November 9, 2016

Re: Pescadito Environmental Resource Center - Webb County
Municipal Solid Waste (MSW) Permit Application No. 2374
Technically Complete Permit Application Supplement Number 3
Tracking Nos. 20877533 and 20683791; CN603835489/RN106119639

CB&I Environmental and Infrastructure, Inc. (CB&I) is providing the attached information to supplement the referenced permit application which was declared technically complete on March 11, 2016. We are providing these changes based on your e-mail request dated October 11, 2016 and in an effort to make the application abundantly clear on the issues. As requested in your e-mail, each specific item of concern is cited below followed by our response:

2
C.2-12
DETENTION BASIN WEST OUTLET CULVERT PASSAGE - SECTION VIEW
NOT TO SCALE

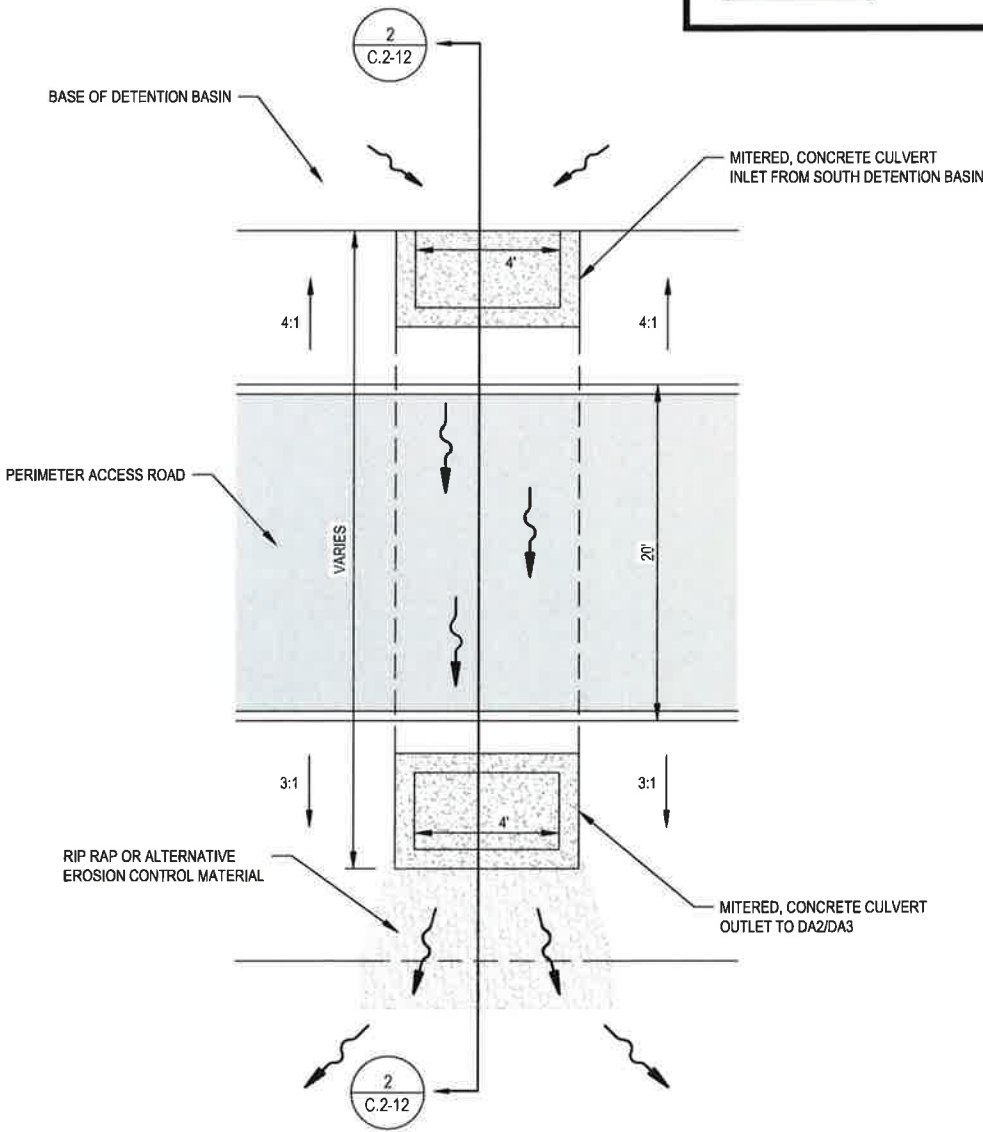
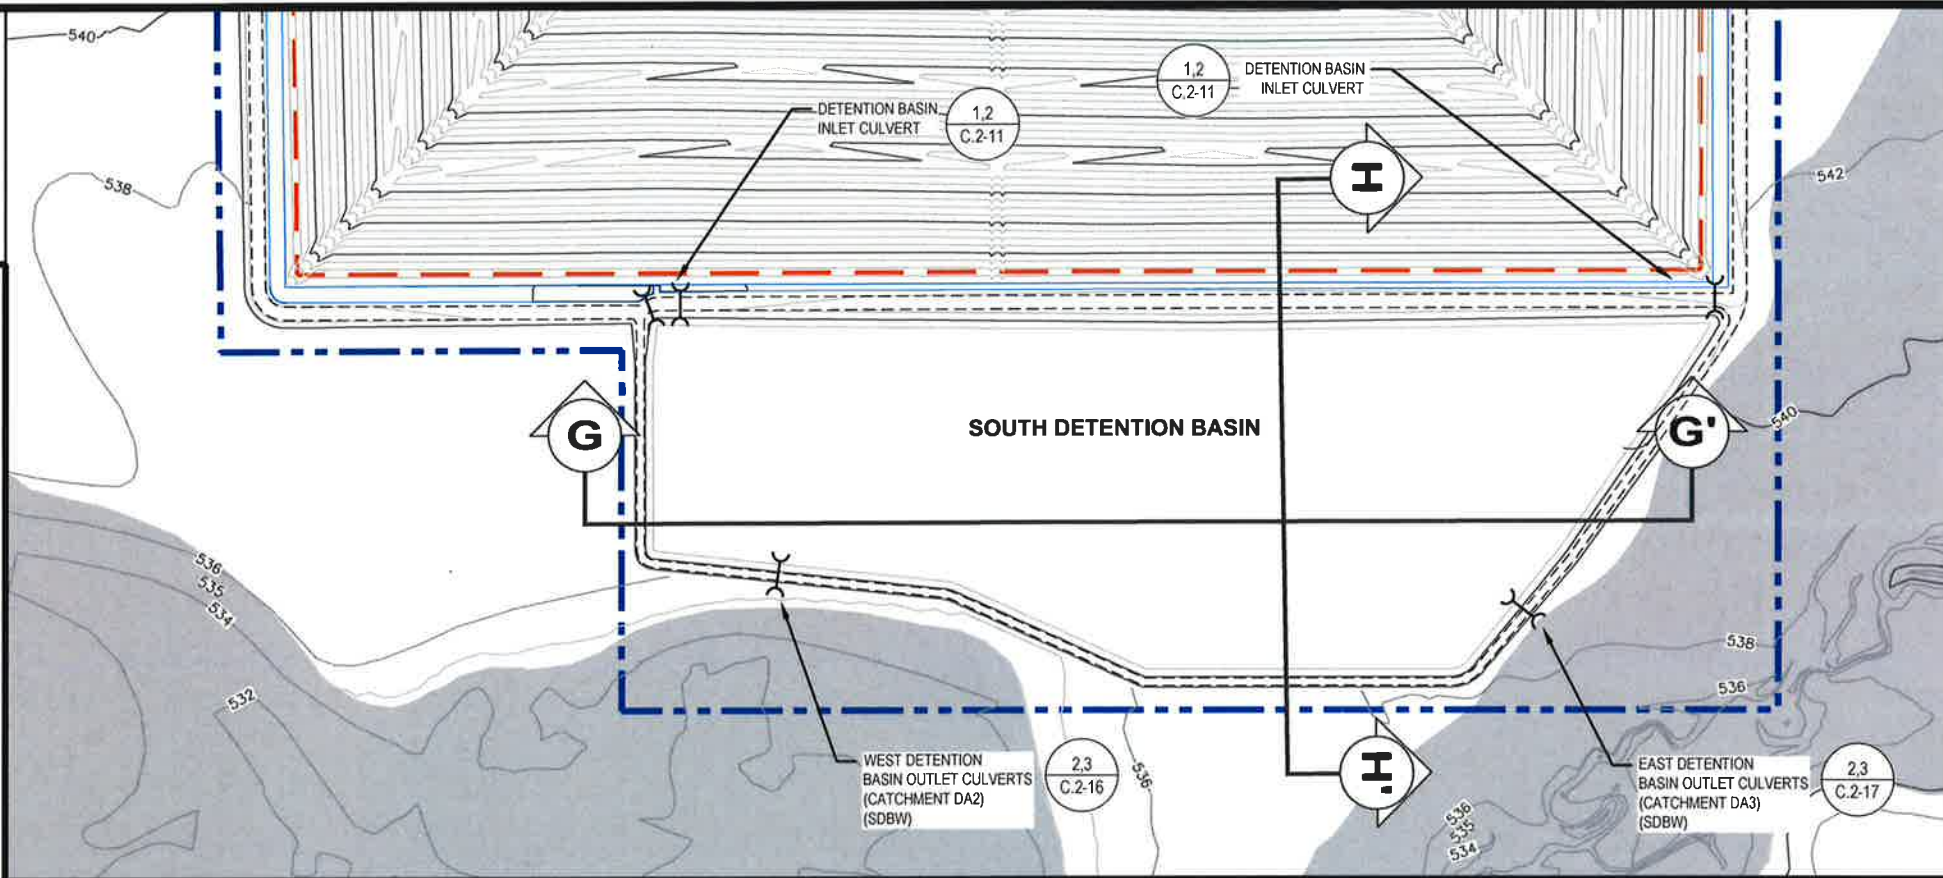
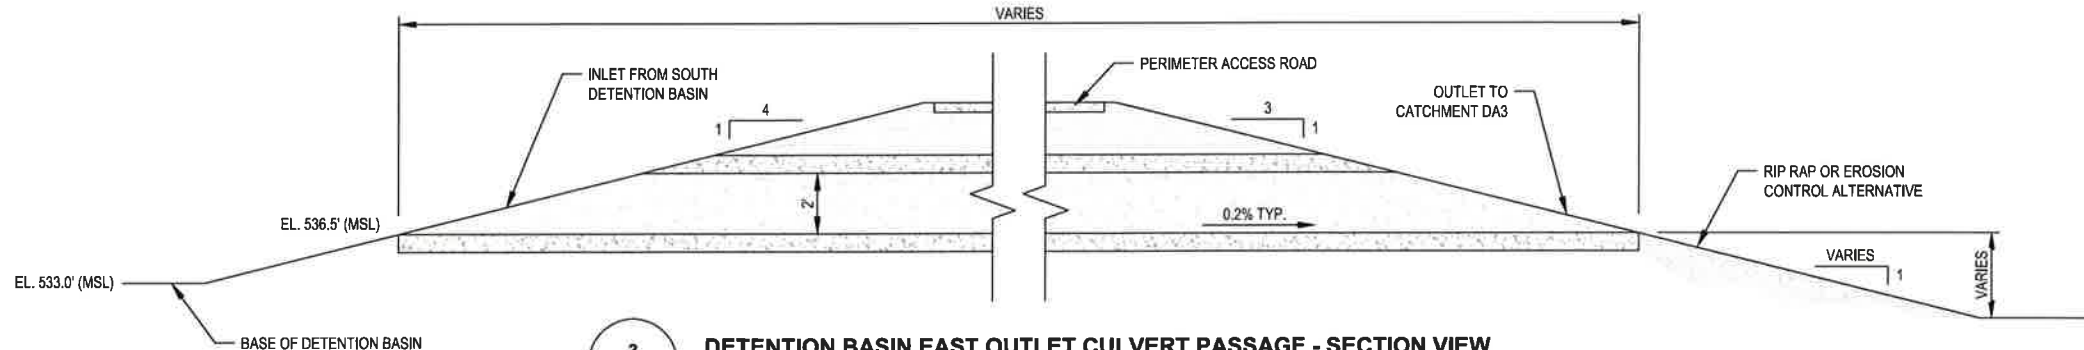
5. The profile drawings of the proposed detention pond indicate that the detention pond will be excavated several feet below natural grade. It is our understanding that the pond is intended to completely drain and not retain any significant amount of collected runoff. Please provide a detail drawing of each discharge structure that depicts how the below grade portion of the pond will be drained by the proposed box culverts. If conveyance structures outside of the permit boundary will be required for the stormwater to be delivered to the natural drainage ways, please provide a discussion and drawing(s) to document these structures. Please provide an easement or similar instrument that will allow for inspection and maintenance of stormwater conveyance structures constructed outside of the permit boundary.

Modified drawings III.C.11 and 12 are provided to better illustrate the drainage from the South Detention Basin. The culverts from the basin discharge into the floodplain on the permitted property and no easements are required.. New Figures III-C.2-16 and 17 are provided for additional detail. A modified Cover Page and Table of Contents, along with the figures listed above, are provided for Part III, Appendix III-C.2.

REV. NO.	DATE	DESCRIPTION
4	11/2016	REVISED CULVERT DETAILS

PROJ. NO.: 148866	DATE: NOVEMBER 2016
DESIGNED BY: -	DRAWING NO. III
DRAWN BY: S.J.	C.2-18
CHECKED BY: RDS	18 OF 18 SHEETS
APPROVED BY: MWO

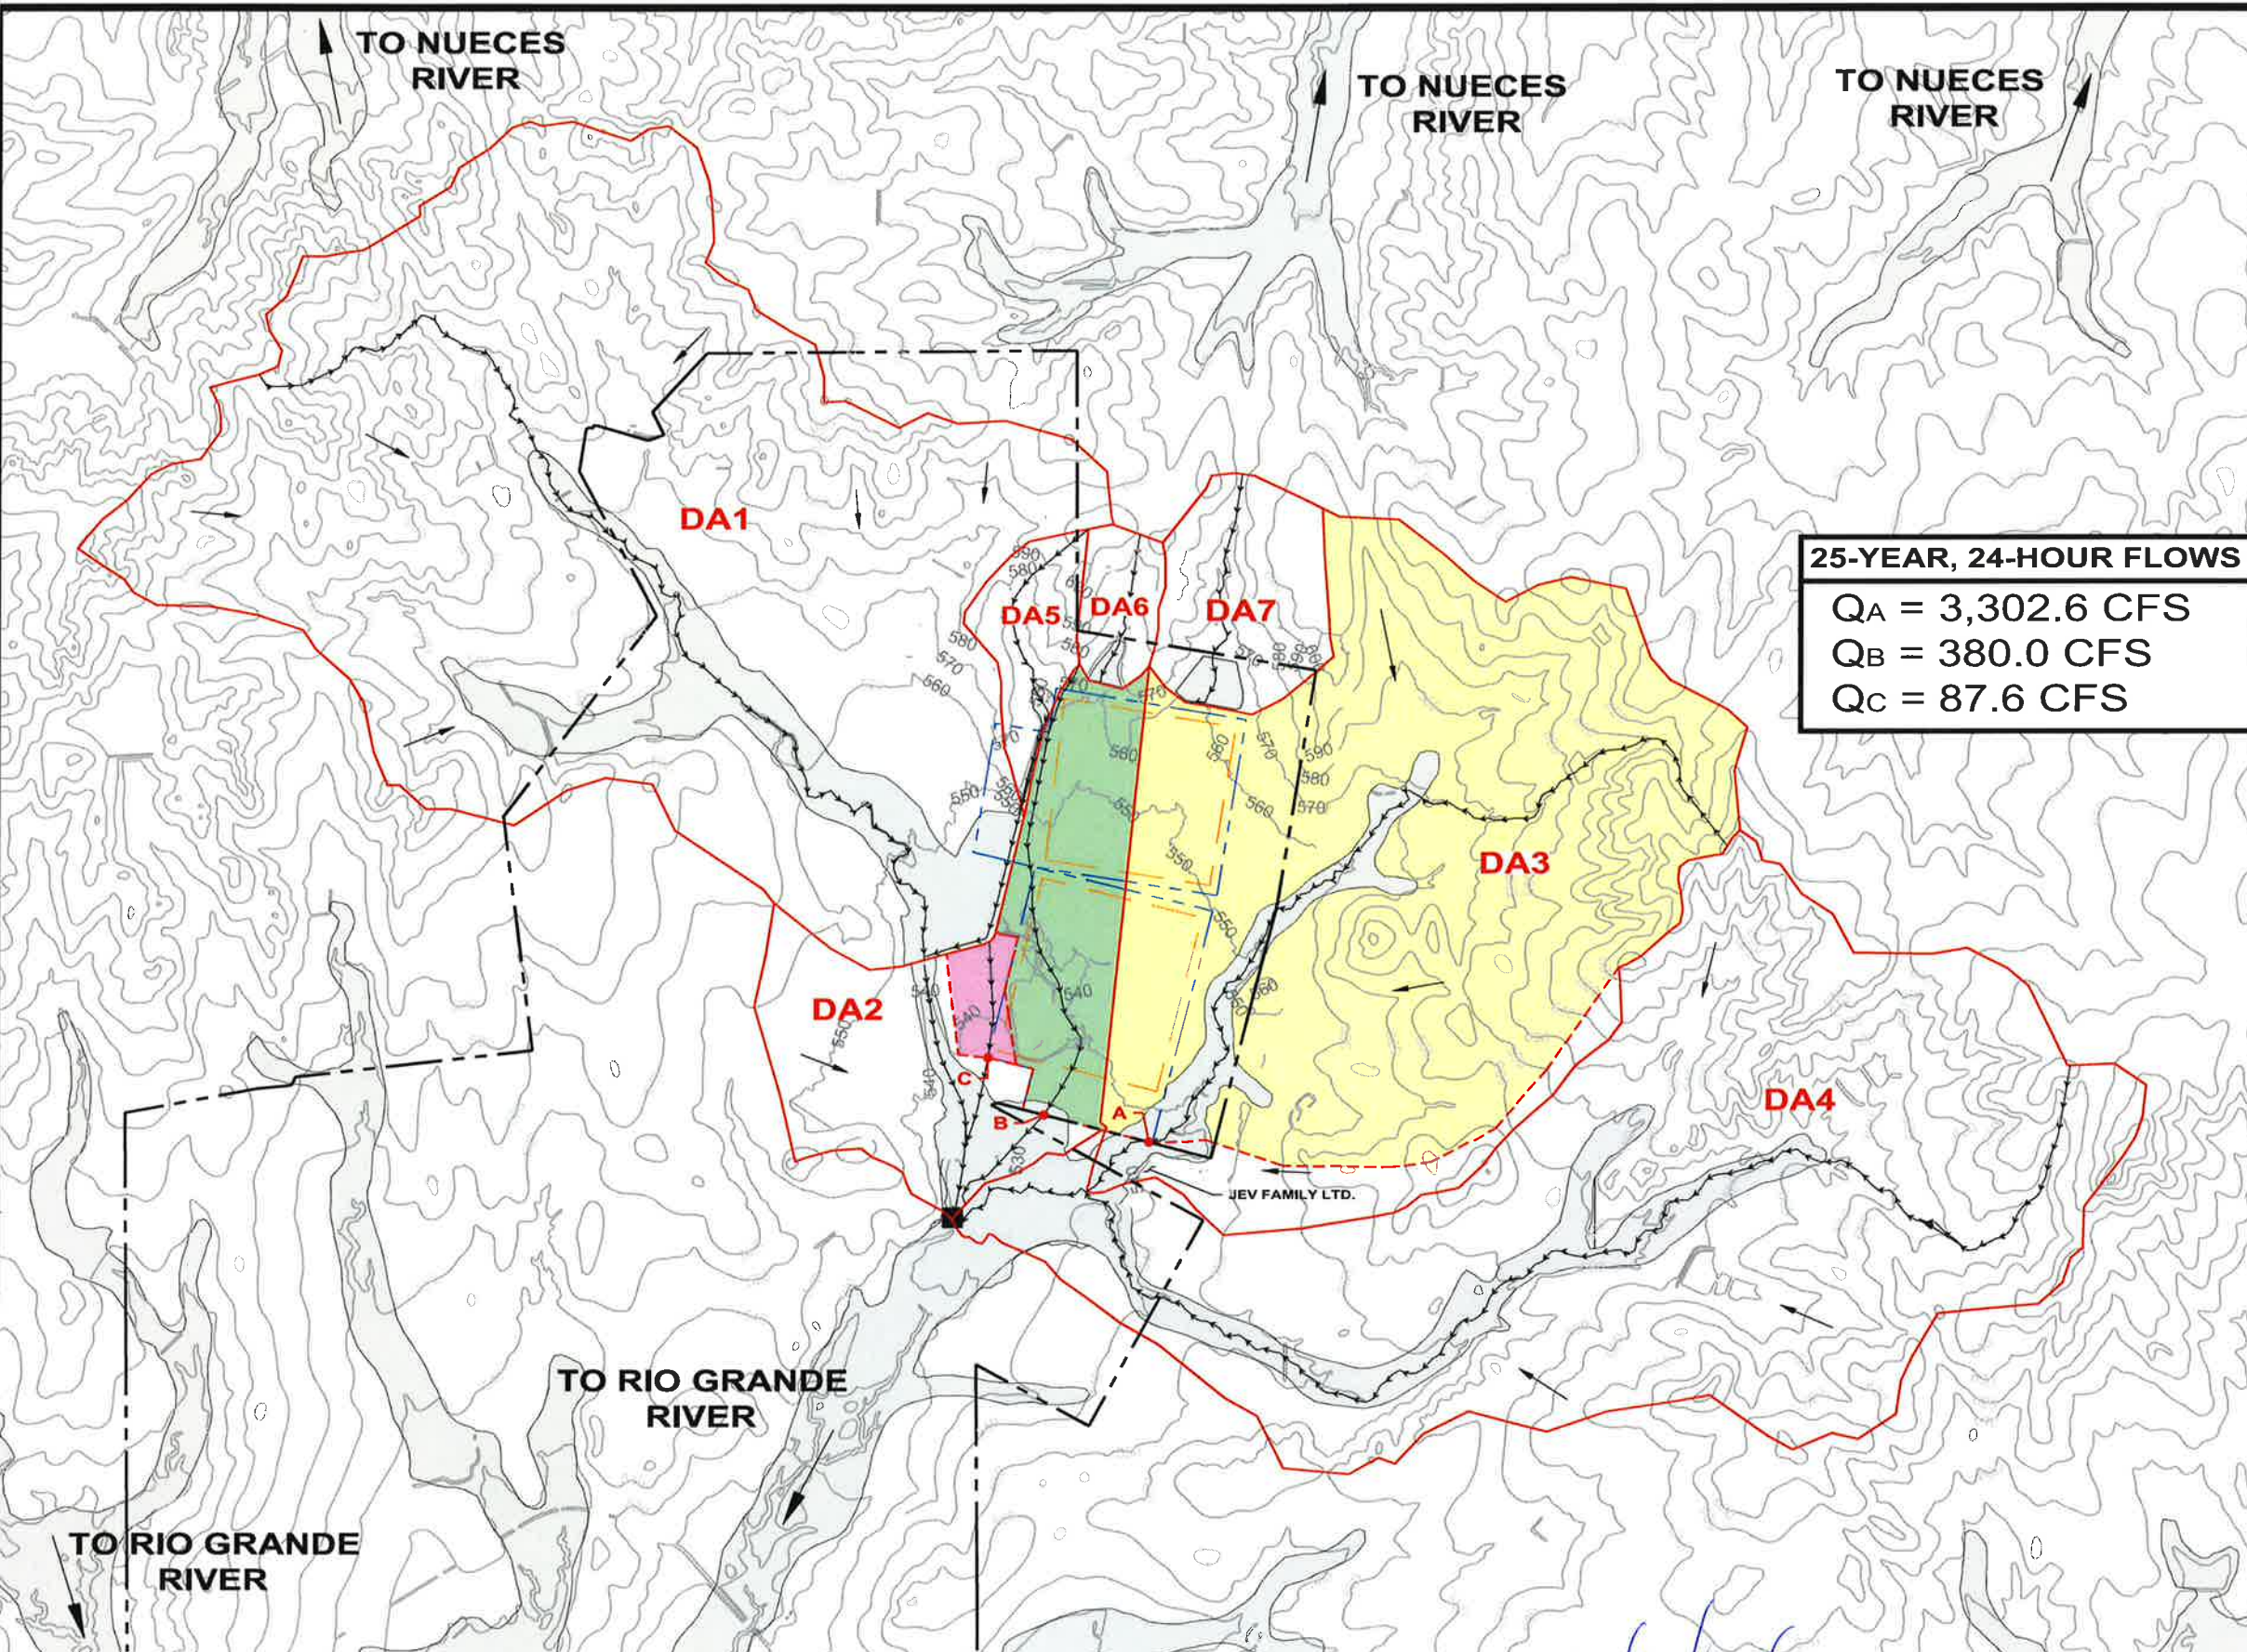
4. The surface water drainage report should be revised to demonstrate that the proposed facility will not adversely alter the existing drainage patterns of the watershed that will be affected in accordance with 30 TAC §330.305(a). The design storm for this demonstration is the 25-year, 24-hour storm. TCEQ Regulatory Guideline RG-417 provides guidance on preparing this demonstration. It is requested that your response to this comment address the procedures presented in RG-417.

Additionally, Figures III.C-2.3, 4 and 5 have been modified to more accurately depict modeled conditions and new Figures III.C-2.18 and 19 have been included as illustration. A modified Cover Page, Table of Contents are also provided for Part III, Appendix III-C.2
